Docket No.15-AAER-6

**NEMA Comments on Proposed Amendments to Appliance Efficiency Regulations;
Revised 15-Day Language**

NEMA Comments on Proposed Amendments to Appliance Efficiency Regulations; Revised 15-Day Language

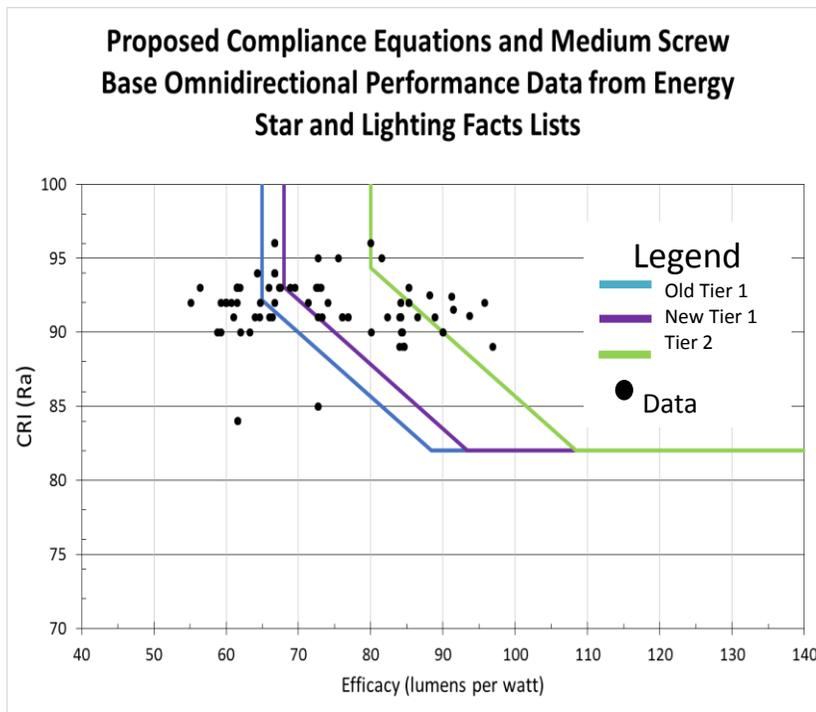
The foregoing graphs copied from the IOU comments to 45-day language¹⁰ seek to illustrate their claim that lamps with an R8 of 72 have a CRI close to 90. They are based on data for omnidirectional lamps taken from the ENERGY STAR and DOE LED Lighting Facts lists. Both show CCT's less than or equal to 3000K. The second figure shows that when using R9 > 32 as a proxy, as the IOUs did, only lamps with a CRI ~ 89 or greater will meet the Tier 1, either new or old.

Figure 1: Comparison of R8 and R9 for 2700K products and 5000K Products

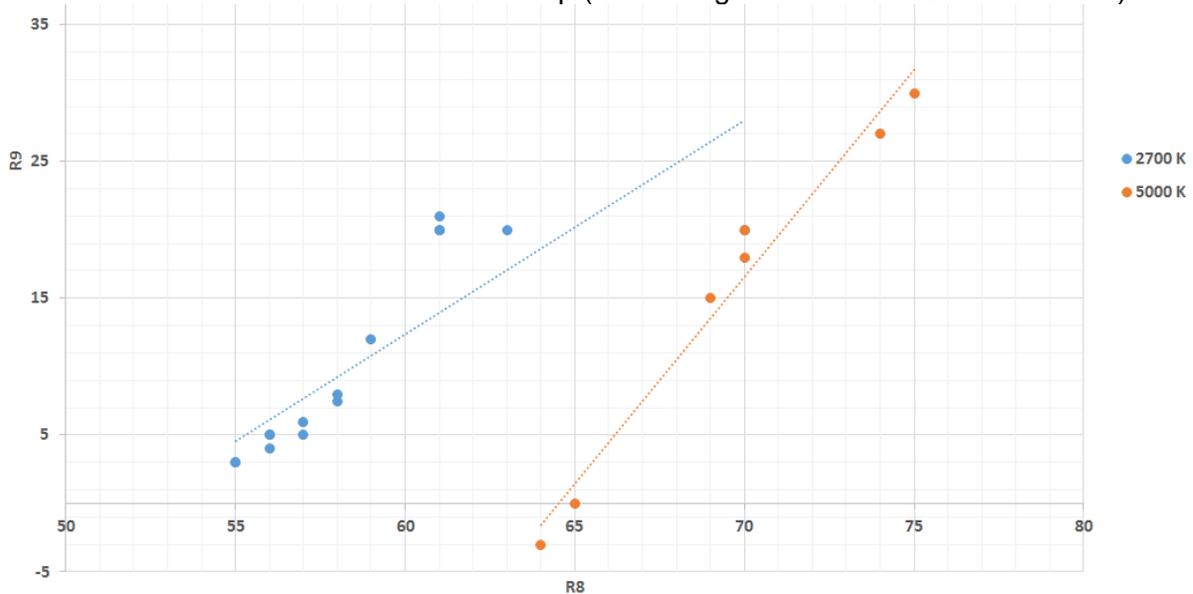
a) In follow up to our example in item 4 above, as we noted in our 45-day docket comments (footnote 1), efforts to justify the use of R9 as proxy for R8 is a significant technical error and inaccurate. As we demonstrated in our 45-day comments, R8 and R9 are related, but not directly proportional and perhaps more importantly they vary by color temperature (CCT). Setting overly burdensome R1-R8 score requirements will incentivize high-CCT lamps ($\geq 5000K$), which consumers will not prefer. The data submitted by Mr. McGaraghan (and repeated in the supplemental staff analysis issued on 12/28) does not include any distinction between high and low CCT for the lamps graphed, and again misleads the public into believing there is widespread product compliance across the typical range of choices demanded by consumers. There is not.

We again provide the following graph of R8 and R9 versus CCT as an illustration of the above described interrelationship (R values gathered from NEMA members):
